# Newmar Corporation

**RSB 619**  
**July 07, 2025**  
**Revised**  
**8/19/2025**

**NHTSA #25V 431**  
**TC #2025-349**

## RECALL SERVICE BULLETIN

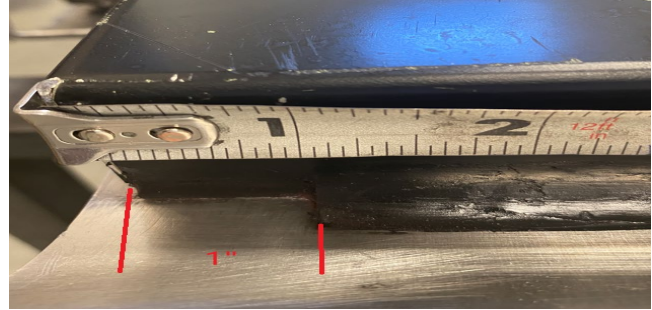
Apply a 5/16" bead of Sikaflex®-252 to all compartment doors at the bottom, leaving a one-inch gap near the corners for drainage should any water get between the skin and door frame.

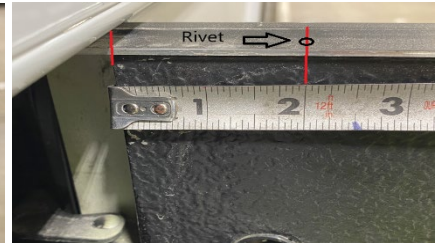
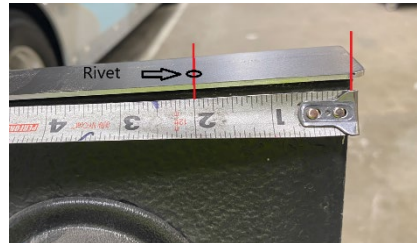
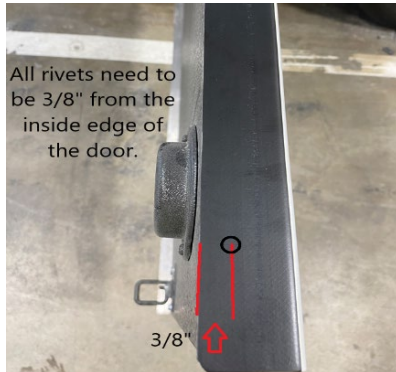
Spray Sika® Slick on the bead of Sikaflex®-252, tool it with a finger, making sure the bead is bonded to the door skin and frame with no voids, except the one-inch at each end.

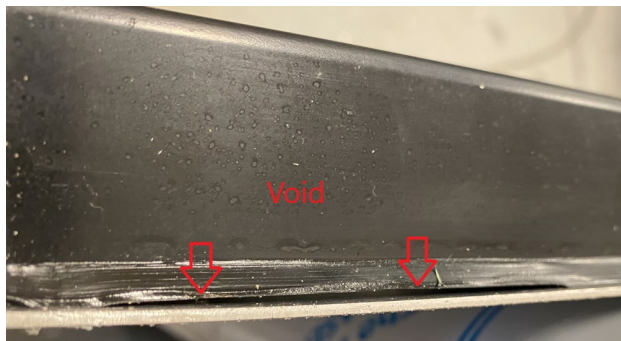
Using a 3/16" drill bit, drill and add three 3/16" rivets along the top (no rivets are needed on top-hinge doors) of each compartment door two inches from the top edge of each side and one evenly spaced in the middle of the two outer ones (measurement will vary based on size of door) and 3/8" from the inner edge of the door frame.
